Before the  
**FEDERAL COMMUNICATIONS COMMISSION**  
Washington, DC 20554

In the Matter of	)	
	)	File No. SAT-PDR-20161115-00108
Telesat Canada	)	
	)	
Petition for Declaratory Ruling	)

**COMMENTS OF WORLDVU SATELLITES LIMITED**

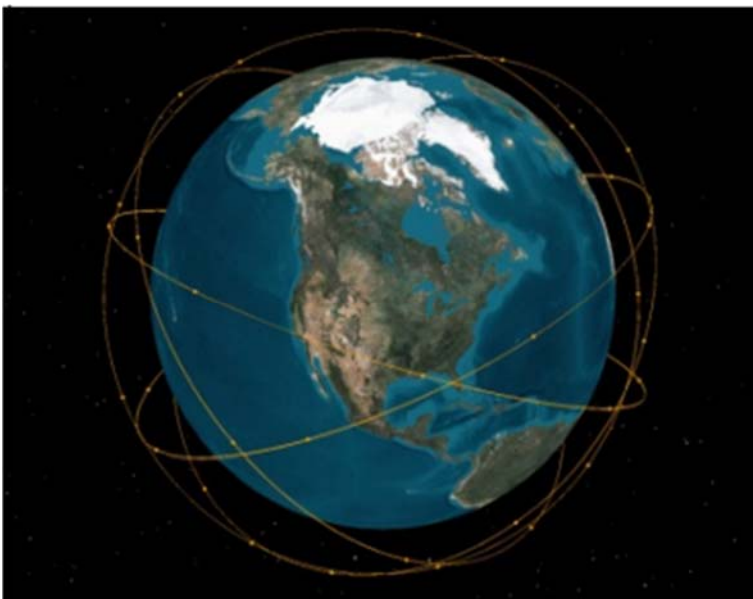
Telesat claims that its inclined orbit planes concentrate coverage over equatorial and mid-latitude areas and provides pictures and videos to substantiate this claim.<sup>27</sup> One such picture, shown below, is not in line with the specifications as provided in Telesat’s Schedule S.

In the above image, taken from the Telesat Technical Annex,<sup>28</sup> the right ascensions of ascending node (RAAN) are likely separated by 72 degrees. However, the Telesat Schedule S has inclined orbit planes distributed in the following RAAN values: 0.0, 36.0, 72.0, 108.0,

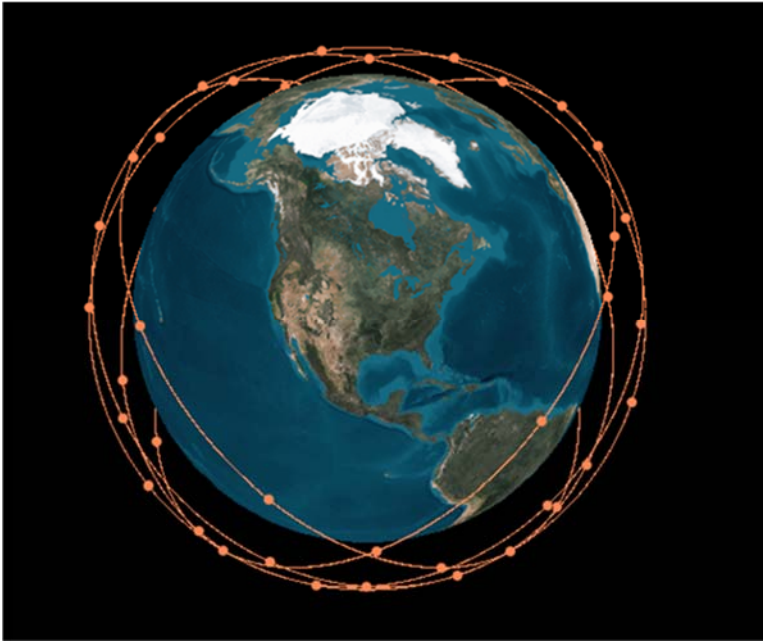
144.0.<sup>29</sup> When modeled according to the Schedule S data, the coverage looks like the image below:

If the Schedule S geometry, rather than the Telesat Technical Annex, represents the planned architecture, the U.S. would have daily coverage gaps. Telesat should update the Commission with its intended design, including details of how it can meet the coverage requirements while also maintaining the required GSO avoidance angles and minimum elevation angles.
